UNIVERSITY OF KENTUCKY Purchasing Division

CCK-2516-21

ADDENDUM # 5

UK 5th Floor Patient Room Fit Out
ADDENDUM No. 5
CCK-2516-21
01/15/2021

LEVEL 0G POWER CANOPY AND DOCK FLOOR PLAN

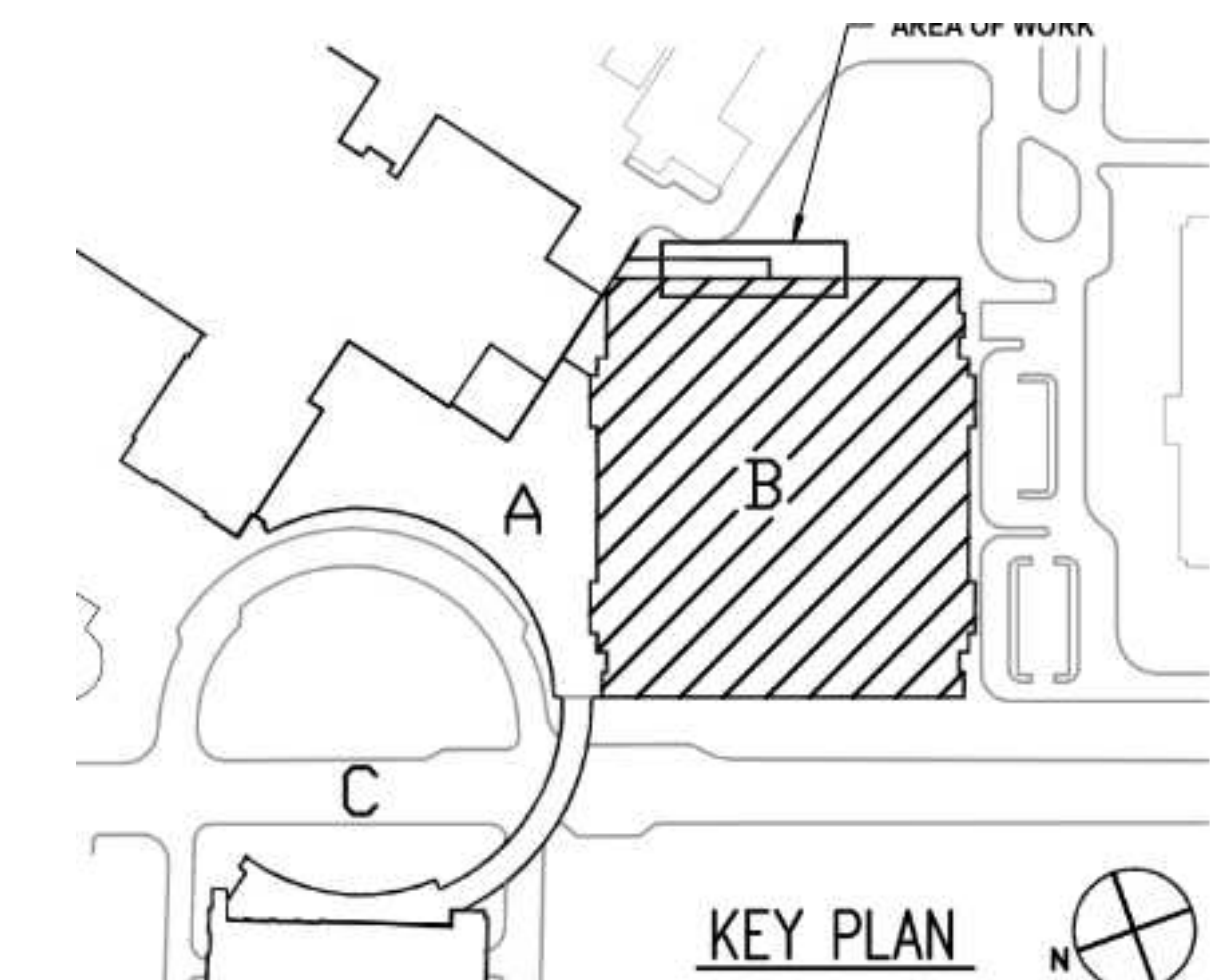
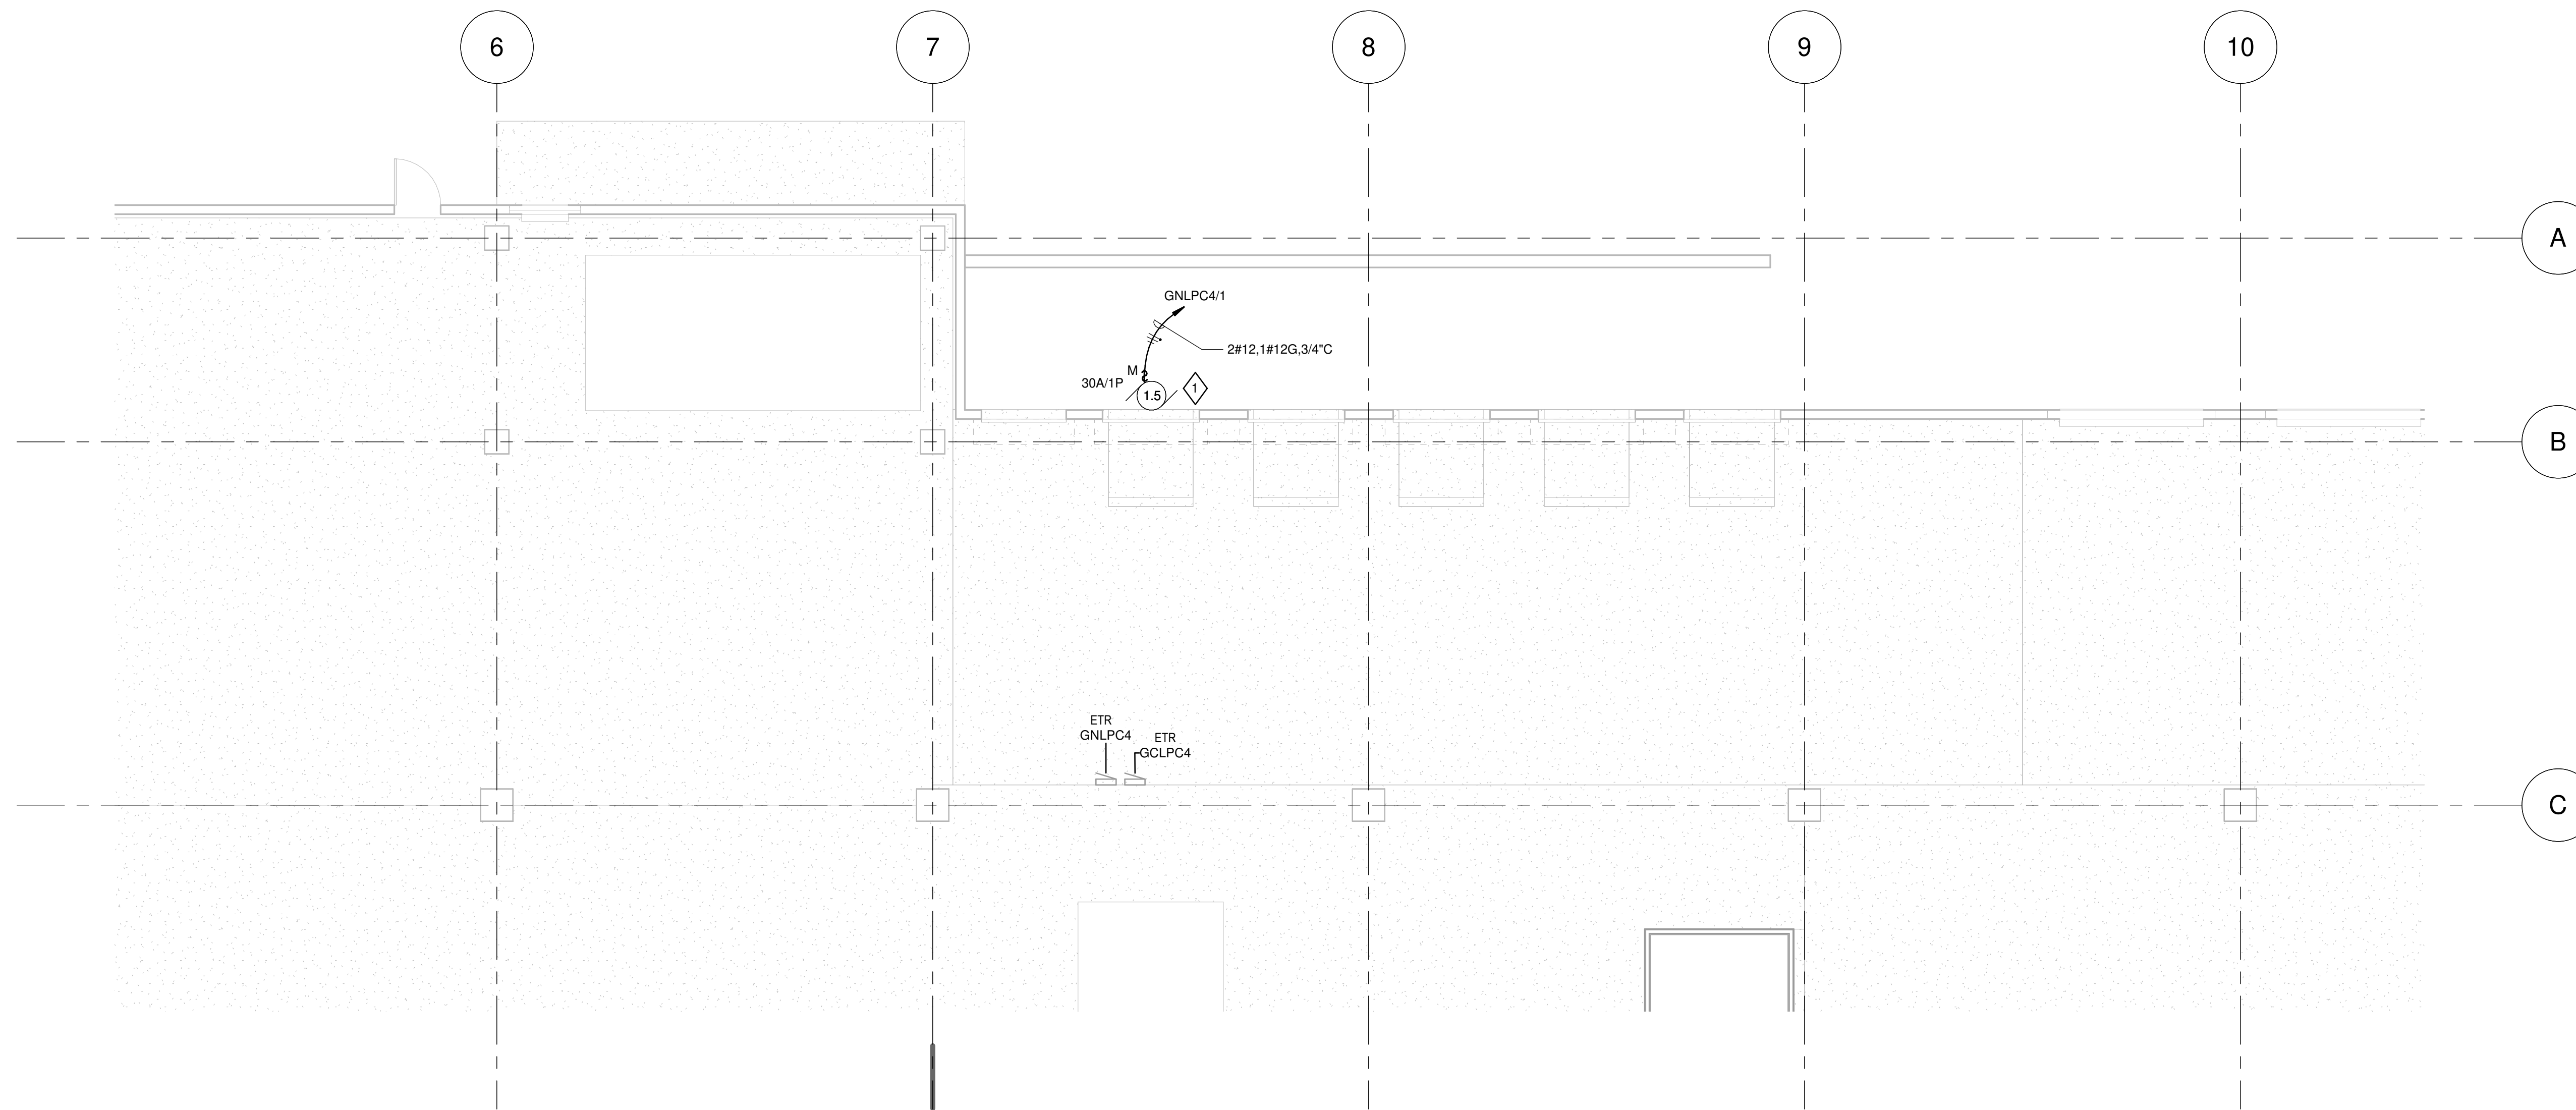
74) This contractor is to provide conduits for new Dock Leveler as shown on drawing A500 and E300. Contractor shall provide all wire and wire up new control panel. Contractor shall include running conduit to power panel. Assume a 60 foot conduit run from the power panel. Contractor shall include providing and installing a new breaker for the dock leveler and landing the wire. (ADD #5)
